DEVELOPMENT REVIEW COMMITTEE (DRC) COMMENT REPORT

PROJECT NAME: Private Club

CASE NUMBER: UDP-S23043

REQUEST: Site Plan Level II Review: 3,500 Square Foot Private Club Use with Associated Parking Reduction Request

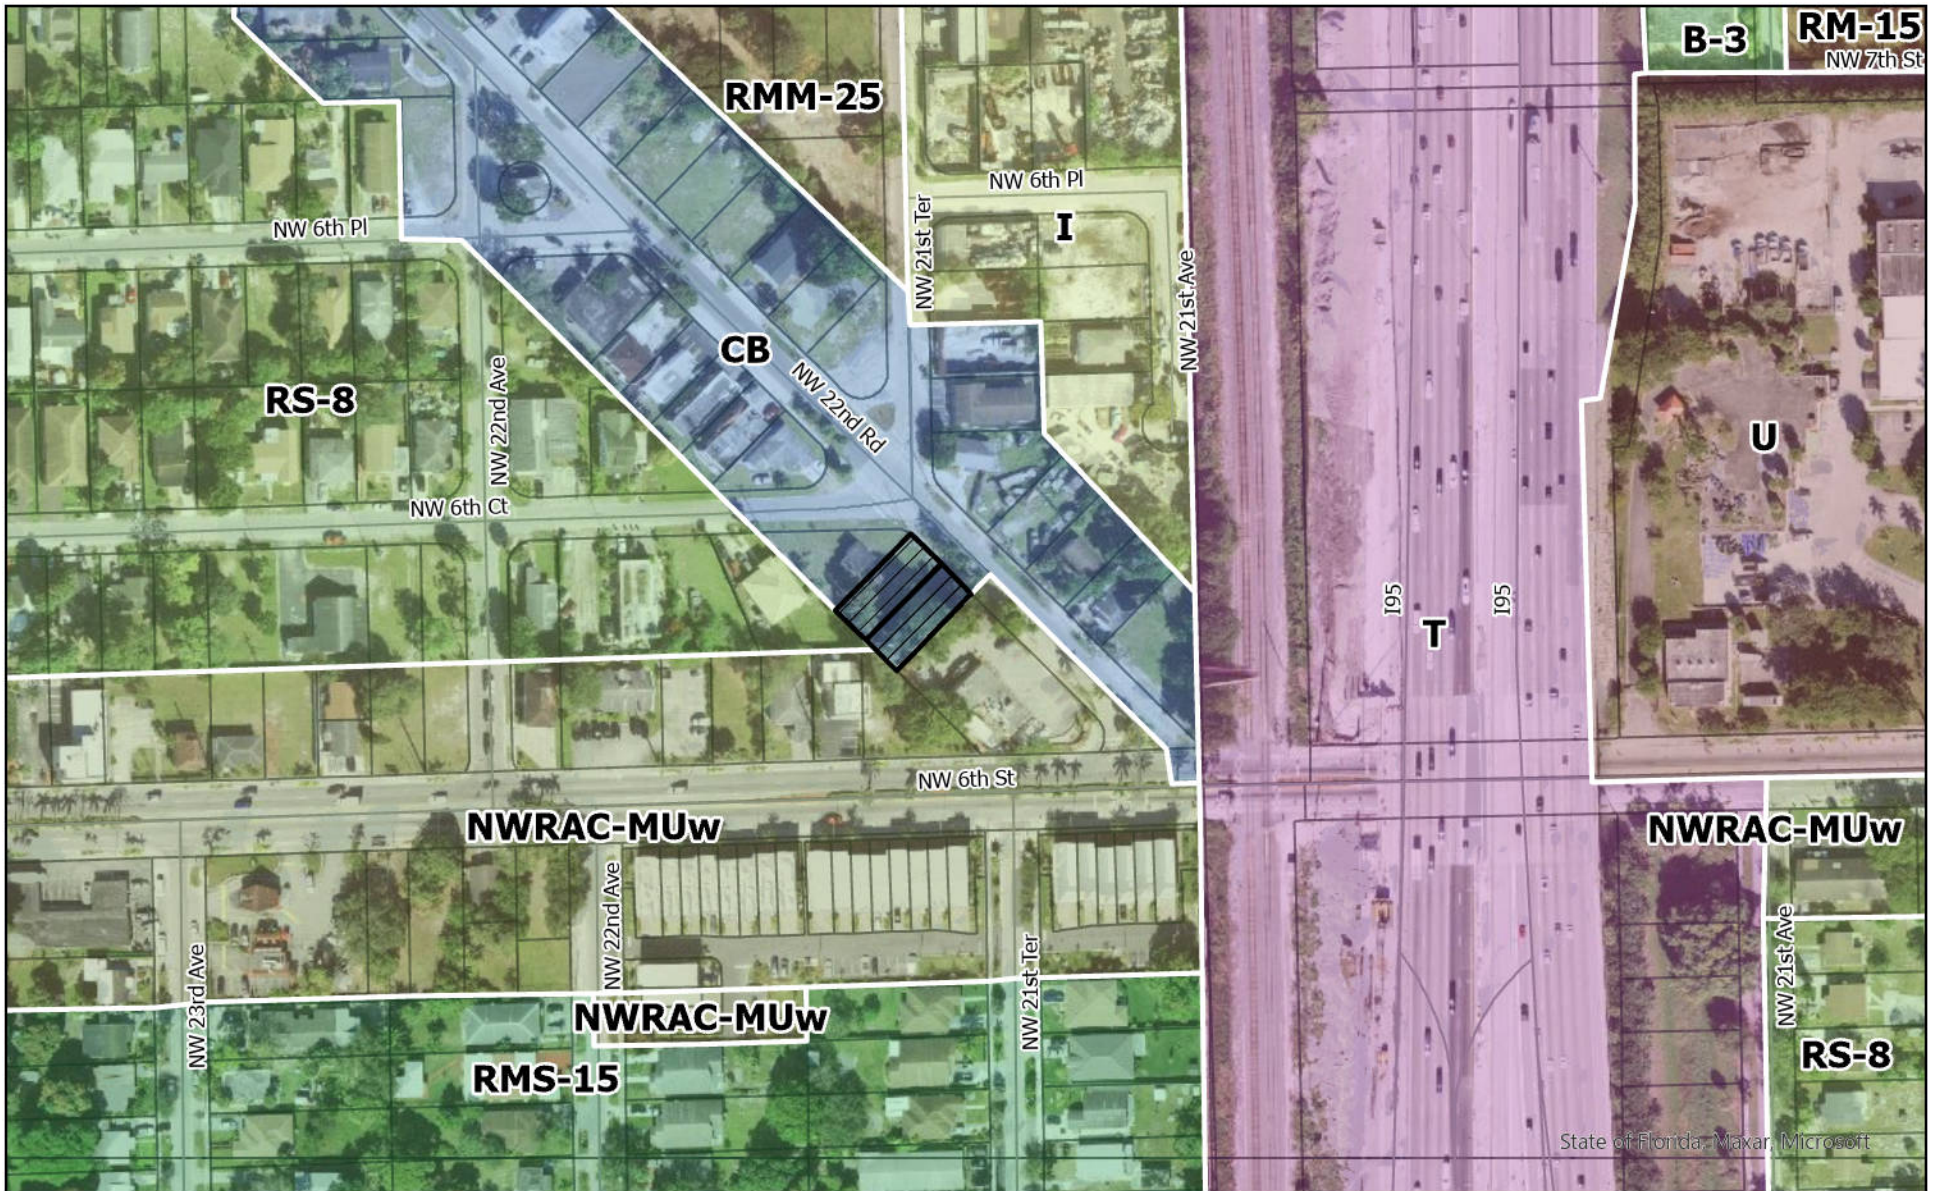
- e. Consider reducing the square footage of the use, in order to meet the parking requirements.
9. Pursuant to ULDR Section 47-25.3.b, control of appearance, the nonresidential building shall comply with this section, including architectural features, fenestration, etc. The building lacks these architectural features required.

Architectural features. The facade of any side of a nonresidential building facing the residential property shall be constructed to compliment a residential structure and shall include the following:

- a. Fenestration such as windows, doors and openings in the building wall; and
 - b. Shall contain a minimum of one (1) feature from each of the following architectural feature groups with a total of four (4) architectural features from the following list:

- I. Detail and embellishments:
 - a) Balconies,
 - b) Color and material banding,
 - c) Decorative metal grates over windows,
 - d) Uniform cornice heights,

- e) Awnings.
 - II. Form and mass:
 - a) Building mass changes including projection and recession,
 - b) Multiple types and angles of roofline, or any combination thereof.

- c) The above required facade treatment shall be required to continue around the corner onto the adjoining wall for a distance of twenty (20) feet.
10. The City's Vision is to support sustainable infrastructure. Consider employing green building practices throughout the project such as, but not limited to; charging stations, tank-less water heaters, rain collection systems, pervious pavement where appropriate, bio-swales, Florida Friendly™ plant materials, solar panels and green roofs.
